From: Jeff Rice
Sent: Thursday, December 3, 2020 8:26 AM
To: Cameron Miller; Kyle Duitsman; Kate Varnum
Cc: Tim McConnell; Elizabeth Nijkamp; Brad Walters; Jeff Hodsdon (jeff@lsctrans.com)
Subject: RE: [External] RE: Falcon Marketplace Paving
Attachments: [IMG_1058.JPEG](#)

Subject: RE: [External] RE: Falcon Marketplace Paving

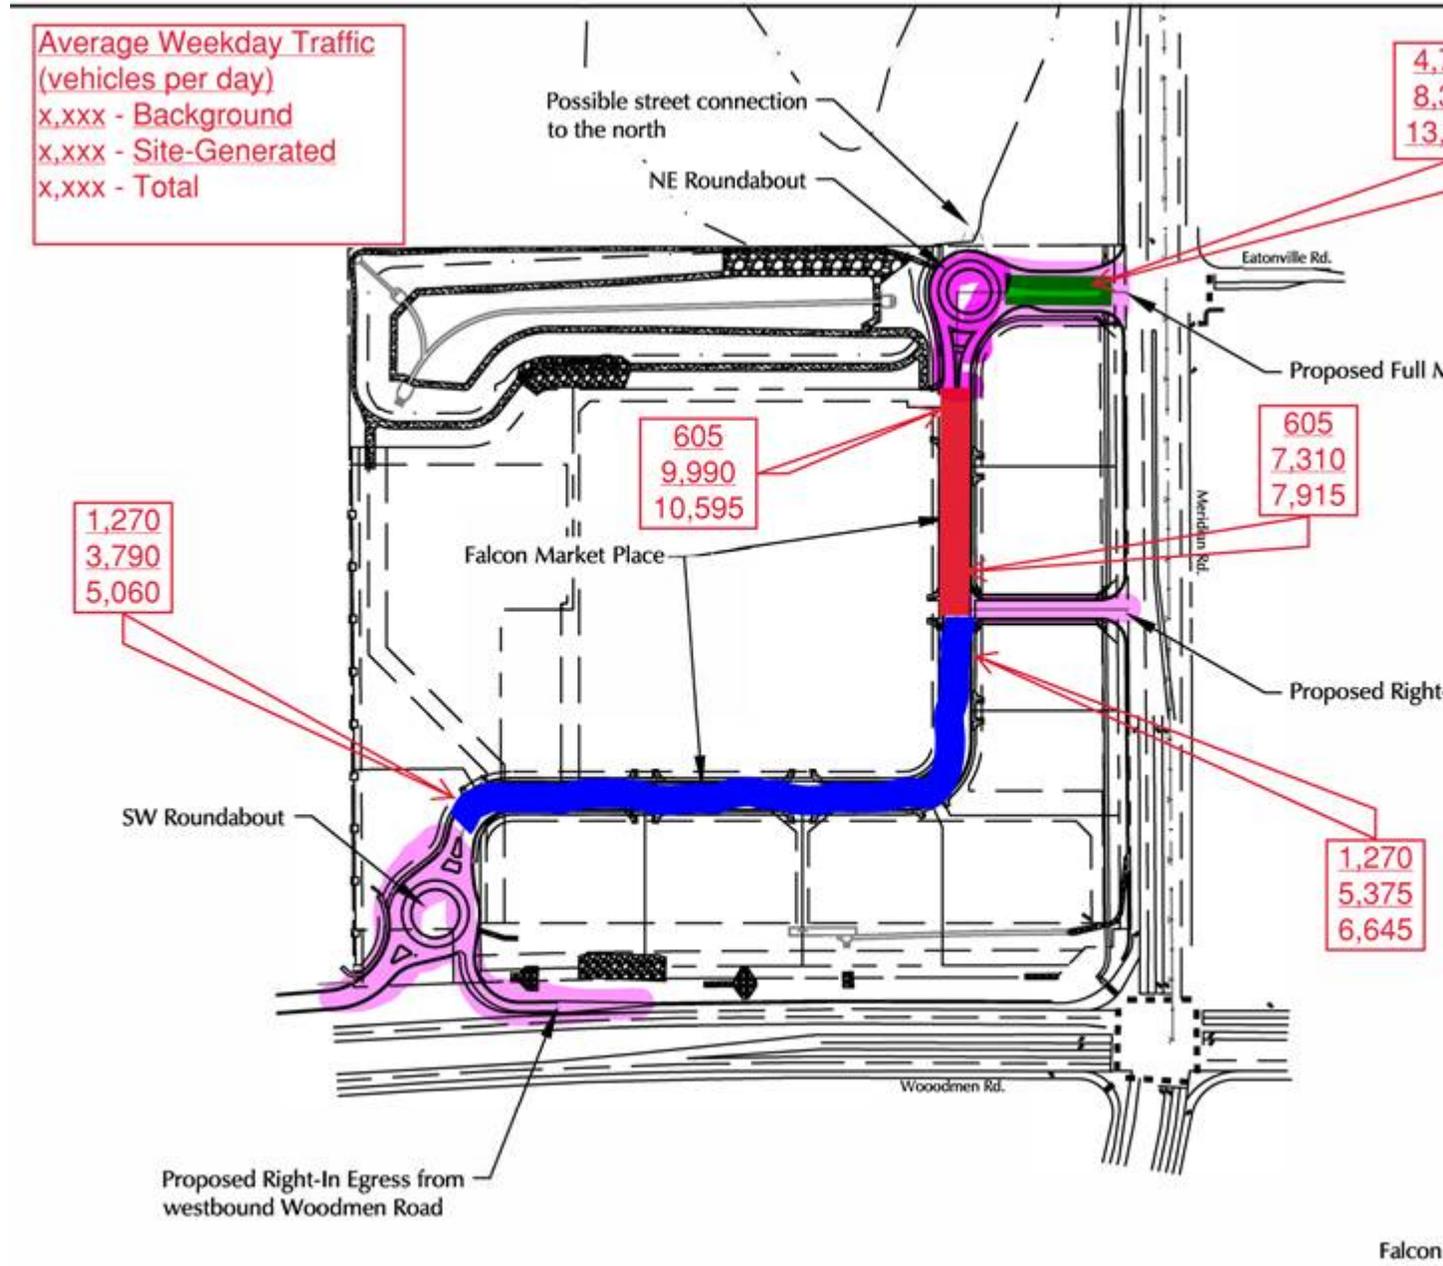
I'm okay with this 5.5" design, but **only** from Sta. 6+00 to Sta. 19+00. The PSI report states that "Concrete pavement at least seven inches thick is recommended for areas which receive continuous repetitive traffic such as entrance/exit drives." With the WIS DOT reference copied below I would like the designers to specifically address the roundabouts and two tight (non-standard) curves in the project. The auxiliary lanes on Meridian Road, decel. lane from Woodmen Road (which should match Woodmen Road pavement section), and the other access road from Meridian (5,000 ADT) will also need to be addressed. I highlighted some of the areas of concern in pink on the image below.

I also don't see Boring 10 (the heaviest traffic area) in the PSI gradation curves/lab test results. The borehole log shows 1 foot of fill over 4 feet of poorly graded sand with silt. I'll try to get hold of PSI staff to ask about that. We have emailed them to get clarification.
